# INTERA/RAML

## Responses to Comments

### Ambrosia Lake Work Plans 2017 and 2018

The following memorandum presents the original comments by United States Nuclear Regulatory Commission (NRC) reviewers of two work plans for the Rio Algom Mining LLC (RAML) Ambrosia Lake site (Site) and the responses to those comments prepared by RAML and INTERA Incorporated (INTERA). Smaller sized figures and tables are embedded; larger figures and tables are attached to this memo.

**Figure 7:** Depth to water at 5-73 ALL and 5-73 ALL-R, which replaced the original well in 2013.

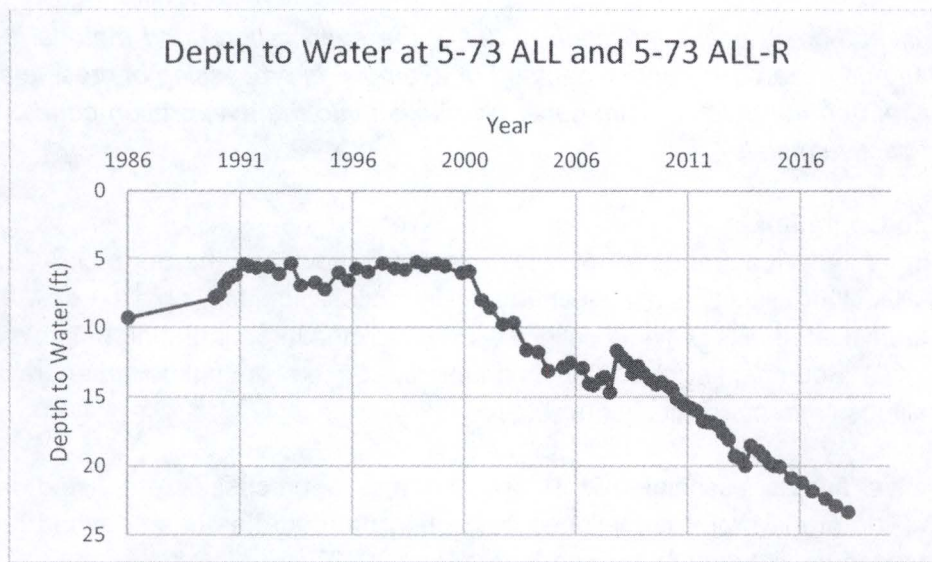
**Comment 7:** *Is there information on the seasonality of water levels, which may also influence contaminant concentrations, in the alluvial sediments along the Arroyo del Puerto?*

- *There are strong inter-annual and intra-annual variations in recharge in semi-arid climates in the southwest, such as at the Ambrosia Lake Site.*
- *With close proximity to the ponds and tailings of the recharge zones for the sandstone layers, there may also be seasonal and inter-annual fluctuations in the water levels of the wells.*

Changes in water levels in each of the HSUs appear to be controlled primarily by surface discharge and drainage of mine water. An overall decrease in water levels has been observed since cessation of mine dewatering and the Corrective Action Program (CAP). Seasonal variability in water levels has not been observed at the Site.

An alluvial monitoring well point was installed in the Arroyo del Puerto in 2014, just south of the proposed LTSM boundary. This well point was installed at the alluvium-bedrock contact and has been monitored quarterly since installation. No water has been observed in this well point since installation. A transducer was installed in December of 2017, at the request of NMED to record potential intermittent saturation in the alluvium beneath the Arroyo del Puerto (**Figure 6** [attached]).

Groundwater elevations in alluvial well 5-73 ALL (and its replacement, 5-73 ALL-R) (**Figure 7** [below]) and TRB well 31-02 TRB (and its replacement 31-02 TRB-R) (**Figure 8** [below]) are plotted over time below.

**Figure 1**  
Dakota Potentiometric  
Surface Contours  
Rio Algom Mining LLC.  
2017 ACL Workplan: Response to Comments

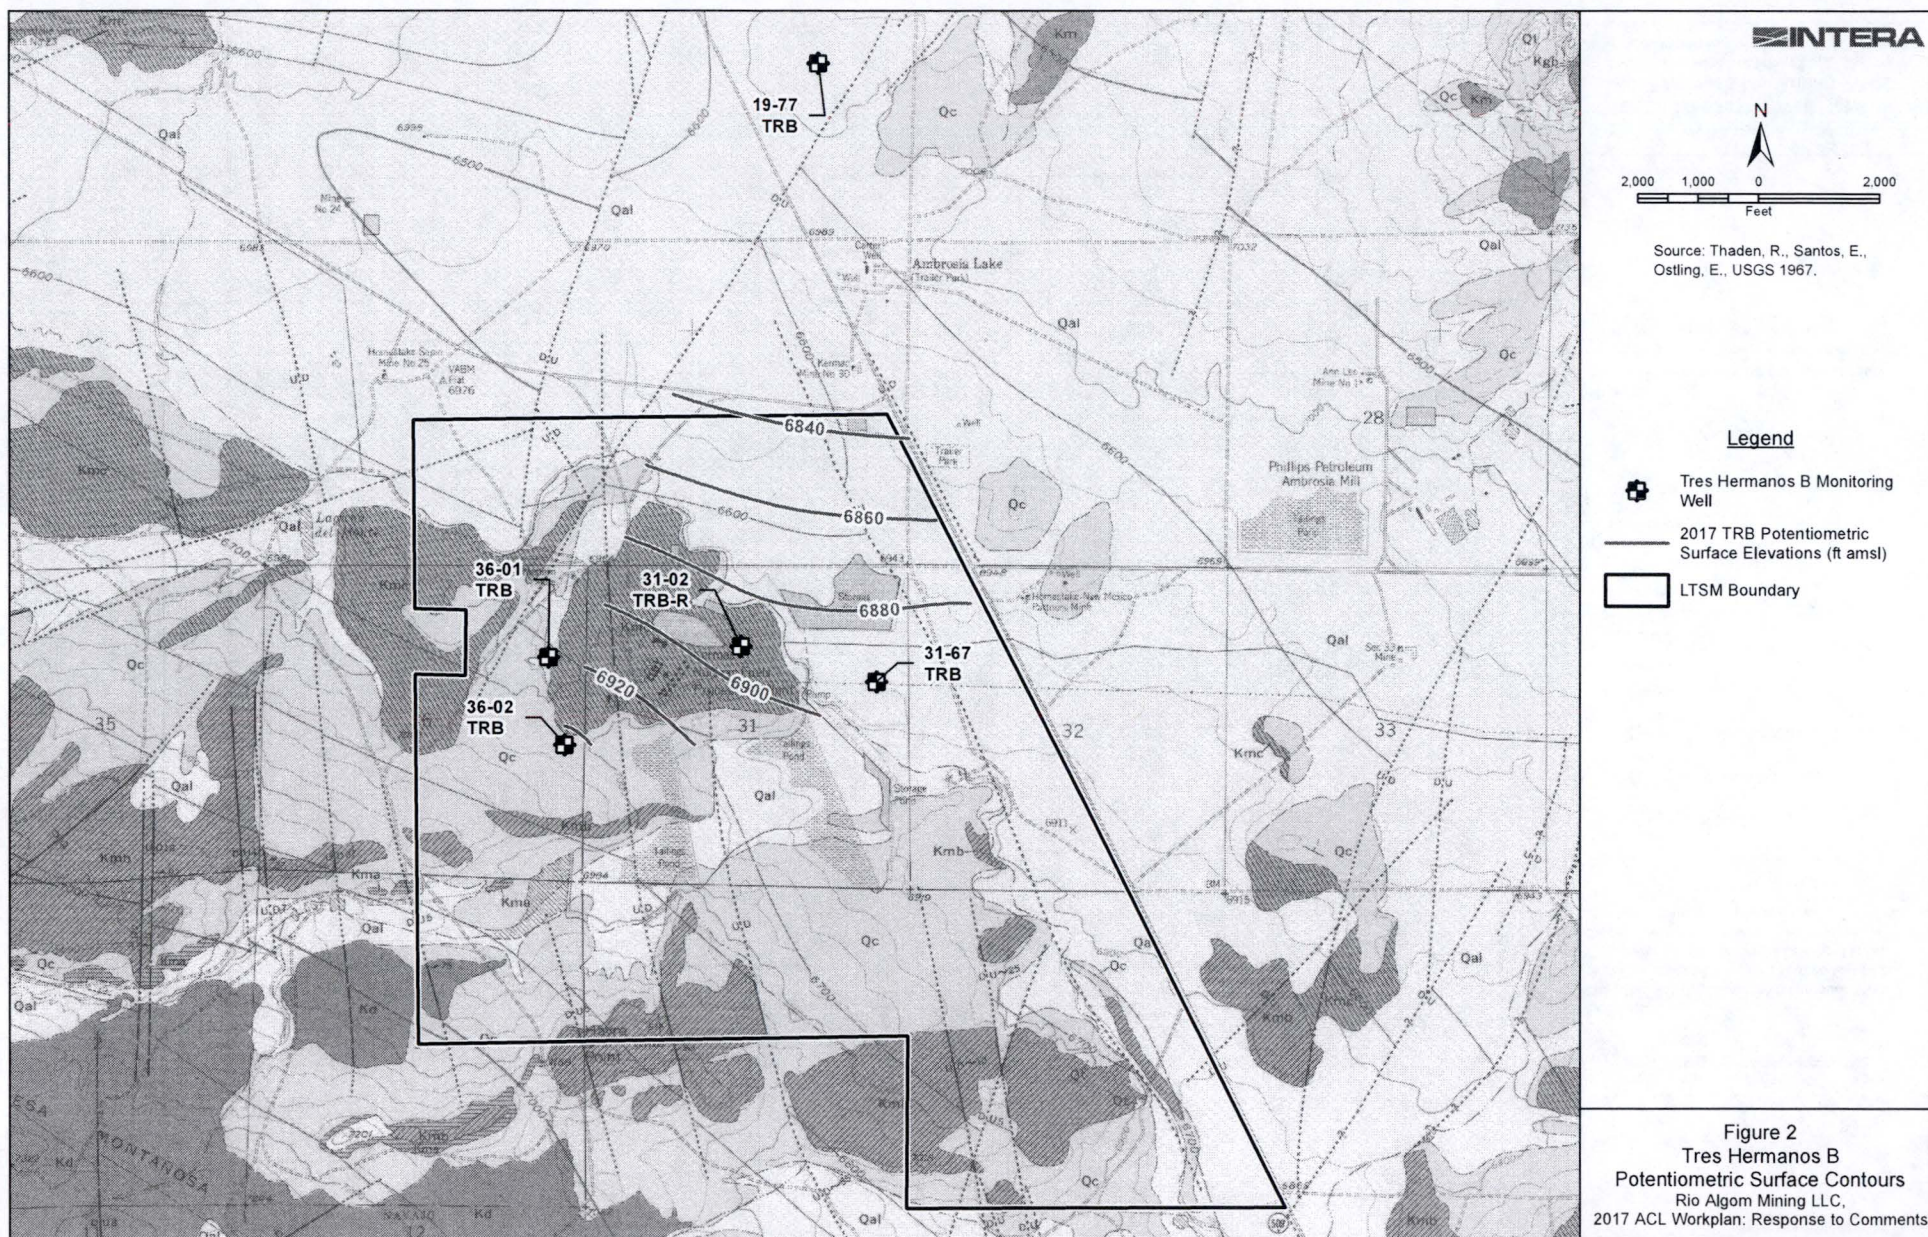
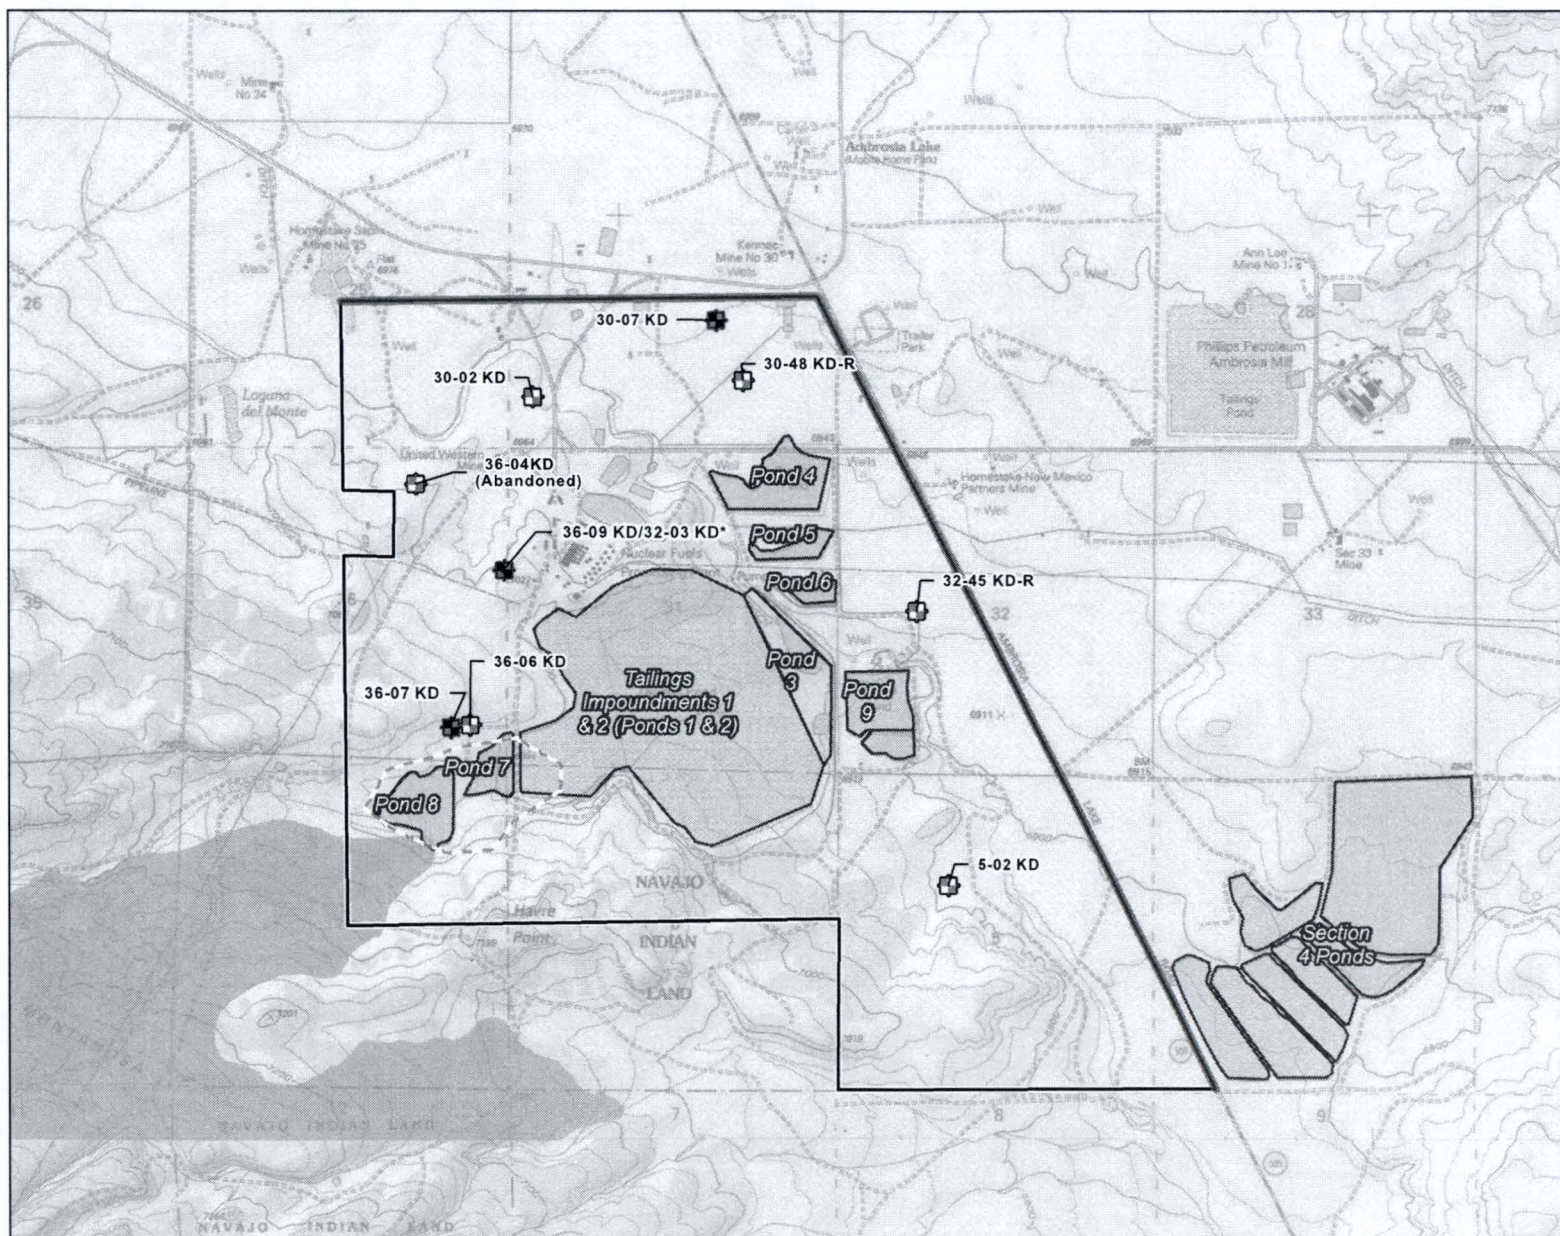
**Comment 3:** *What are the roles of faults and paleotopography in transport pathways? Would leakage through faults change the monitoring strategy? Would transport pathways along faults or paleochannels change the monitoring strategy?*

- *The subcrop patterns of the sandstone units appear to strongly exhibit the influence of faults and paleotopographic features (e.g., paleo-channels).*

- *Transport pathways from POC to POE wells are crossing faults and ignoring paleosurfaces. For the latter, however, it is acknowledged that the topology of bottom surface of each sandstone unit is more relevant to the transport pathway than the top (subcrop). The bottom surface topology is not known, but would unlikely be flat.*

(**Figures 1 and 2** [attached]; Santos and Thaden, 1966). Offsets of other faults near the LTSM area range from 2 feet to 25 feet (**Figures 1 and 2** [attached]; Santos and Thaden, 1966). Offset is not indicated for many of the faults. Also evident from the USGS map is the limited extent of the faults in the area. It is unclear whether the limited extent of a fault was supported by data or whether data was not available with which to continue mapping the fault. If a fault is of limited extent, its influence on groundwater flow would likewise be expected to be limited.

Figure 5  
 Tres Hermanos A Monitoring Well  
 Network with Proposed Monitoring Wells  
 Rio Algom Mining LLC  
 2017 ACL Workplan: Response to Comments

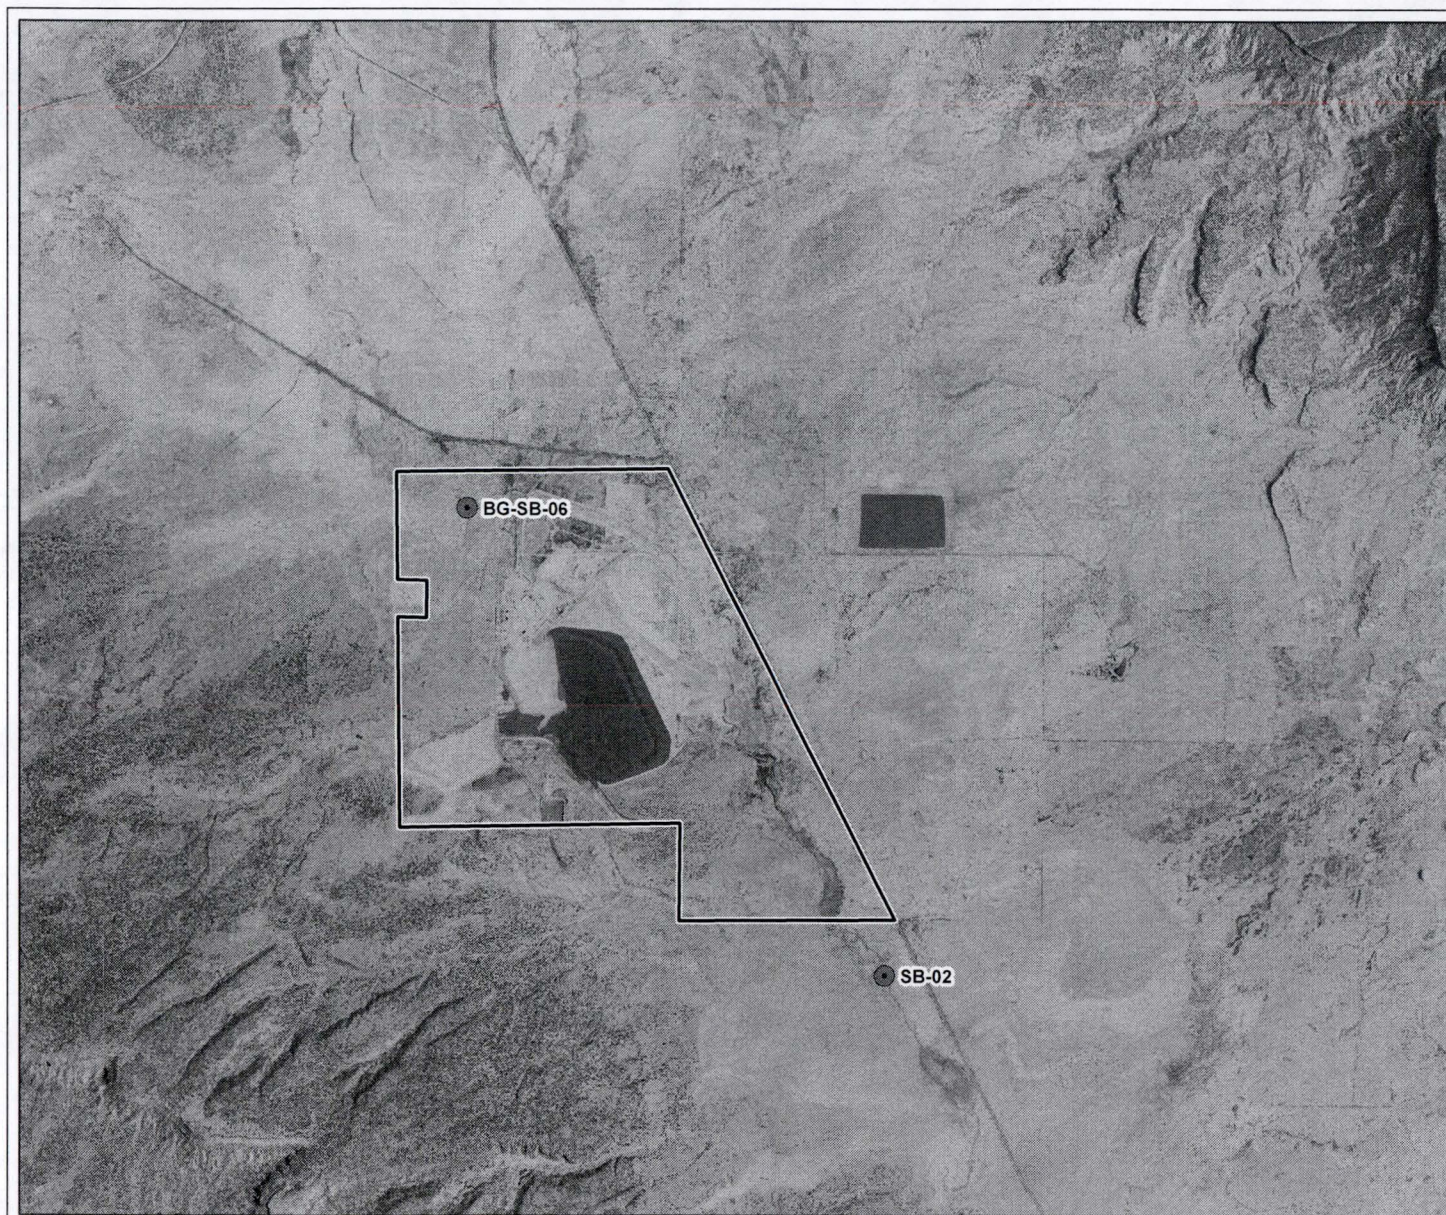
**Comment 2:** *Why does the groundwater gradient in the TRA differ from that of the TRB and Dakota? The direction of groundwater gradients may influence site-wide groundwater conceptualization, and in particular the placement of wells.*

- *Dakota and TRB groundwater gradients are to the NNE, while TRA gradient is currently drawn to the WNW.*
- *In earlier years, the groundwater gradient of the TRA was more northerly, and was based on 5 or 6 wells. In the past several years, the WNW direction of the TRA gradient was based on three wells that fall along a line – a situation that leads to high uncertainty in determining groundwater flow direction and magnitude. The proposed TRA wells in the work plan should help alleviate this problem.*

- *Also, the most easterly well, 33-01TRA, may not be hydraulically connected to the TRA wells to the west. It is located on the eastern side of the fault that traces the Arroyo del Puerto. The offset on this fault large enough such that the TRA unit would not appear to have hydraulic connection across the fault (cross-section of Figure 1.3 in Maxim, 2001); the TRA on the west connected with KD on the east.*

It is agreed that one or more wells are needed within or close to the Long-Term Surveillance and Maintenance (LTSM) area and located relative to existing wells to provide a more reliable estimate of the hydraulic gradient within the LTSM area for the Tres Hermanos A Sandstone (TRA) aquifer. It is not clear what the offset is of the fault underlying Arroyo del Puerto since an offset is not provided on the USGS geologic map (Santos and Thaden, 1966). See the Response to Comment 3 below for additional discussion.
